# DeKalb County Historic Preservation Commission

## Staff Report

- L. 1201 Springdale Road, Warner McConaughey. Demolish greenhouses, construct a new garage, modify driveway, install wooden fencing, and construct a back deck. **1246967**

# EDUPUGANTI RESIDENCE

RIGHT SIDE ELEVATION  
1/4"=1'-0"

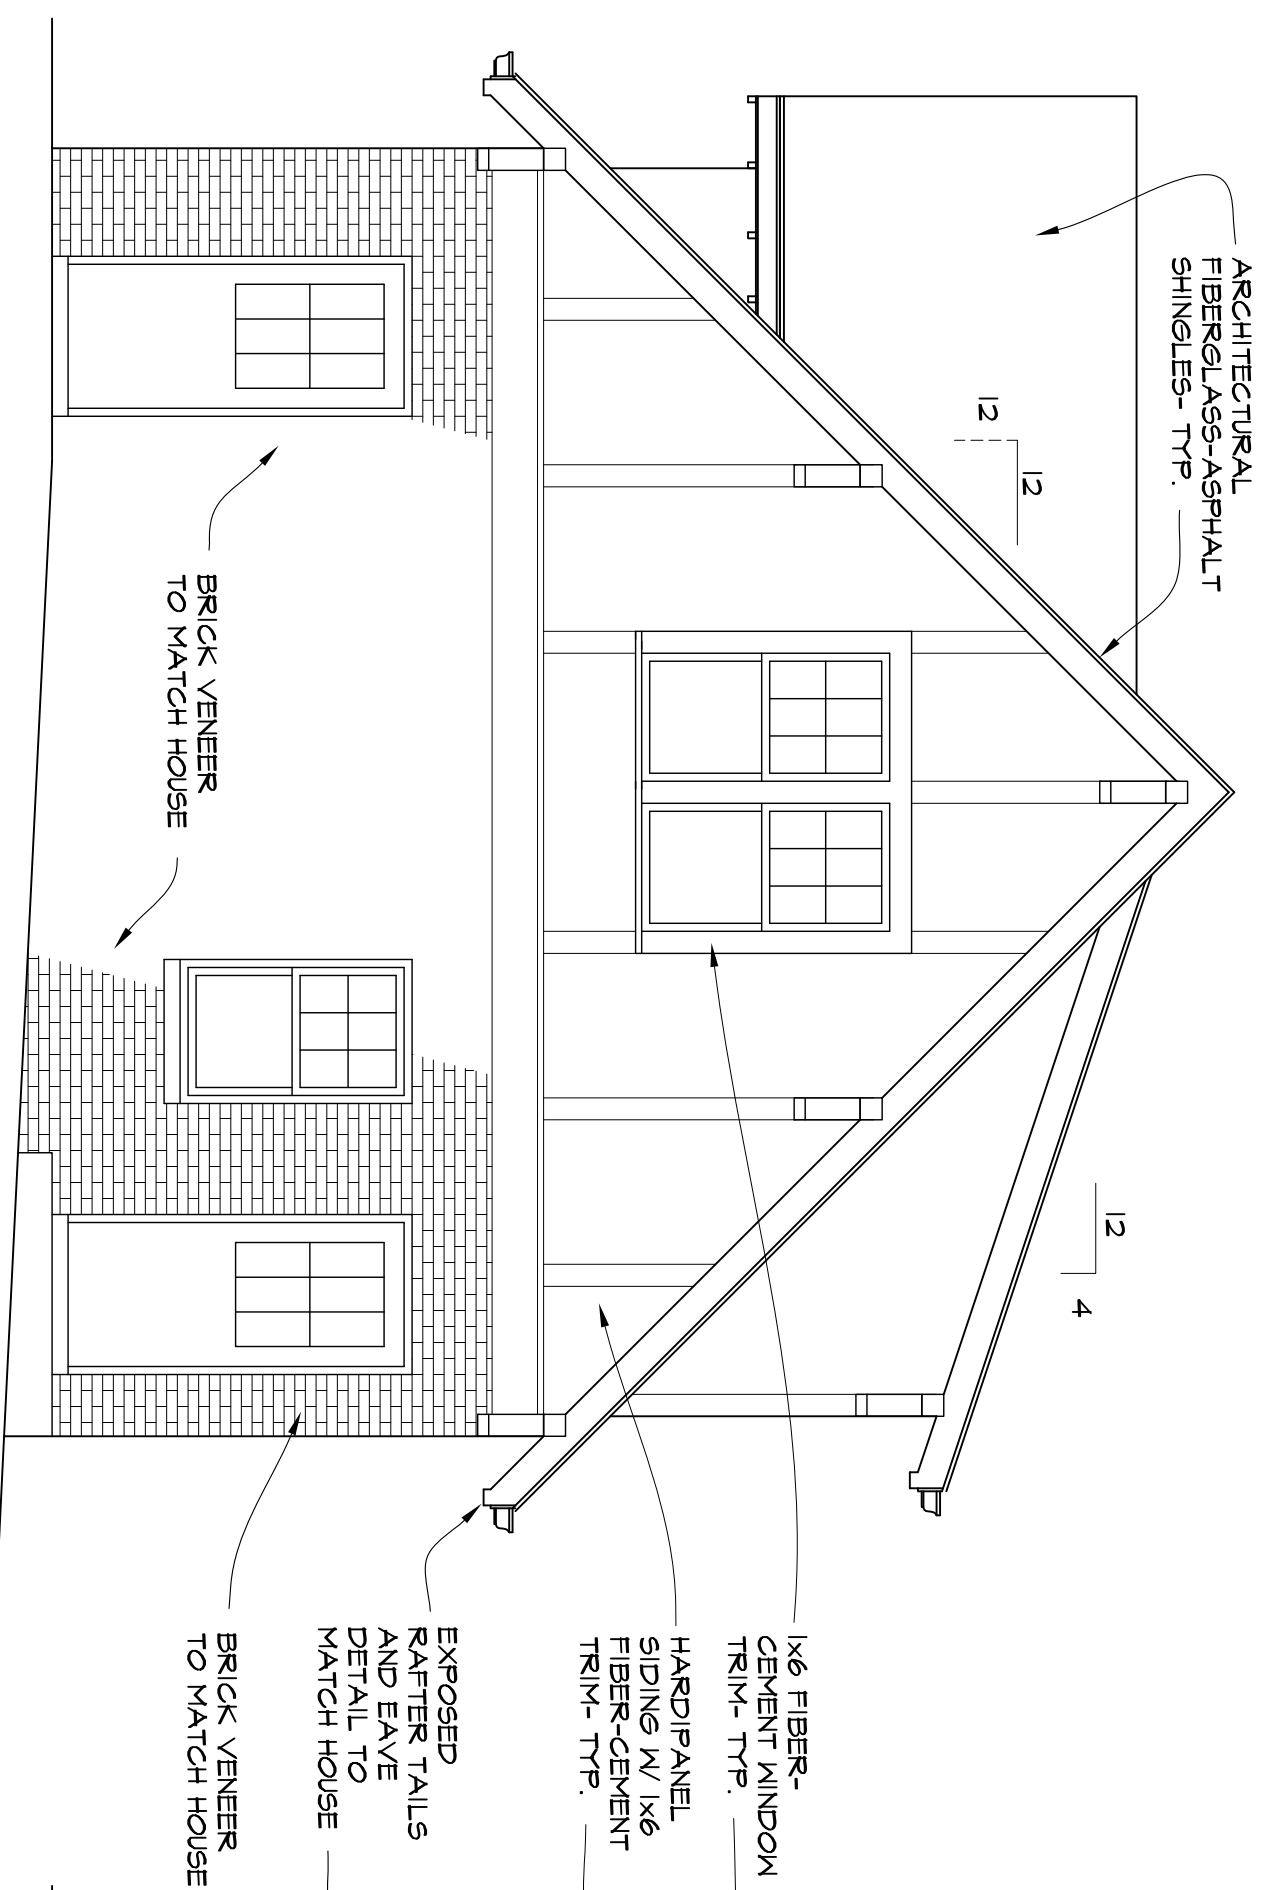
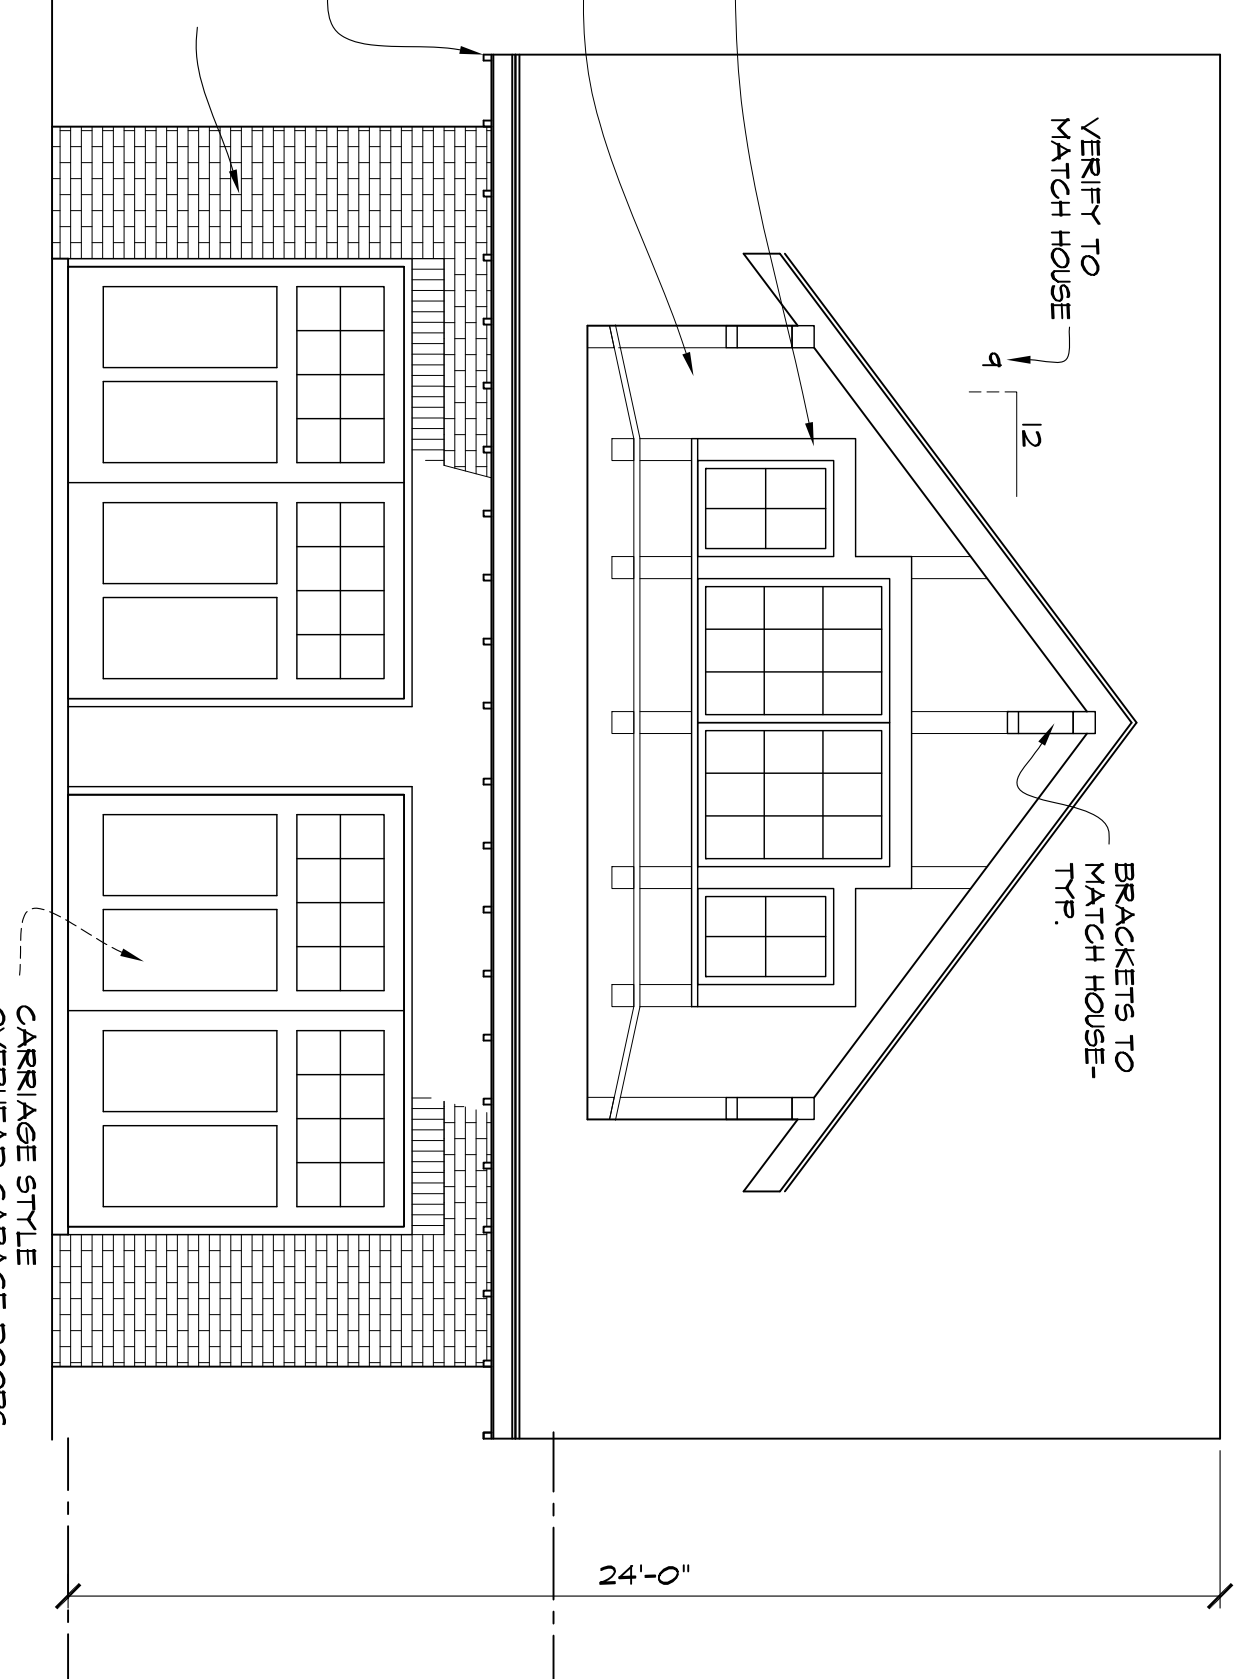
tomorrow morning. A quick final question before we finalize the report: What is the height of the home? And can you confirm that there will be no exterior changes to the main property, only interior renovations?

The existing house seems to be about 26' tall, as measured from the finished first floor of the house.

The proposed garage slab would be about 5' below the finished floor of the house. So from the finished grade across the front of the house, the house is about 29 feet tall. The garage would appear to be 19 feet tall.
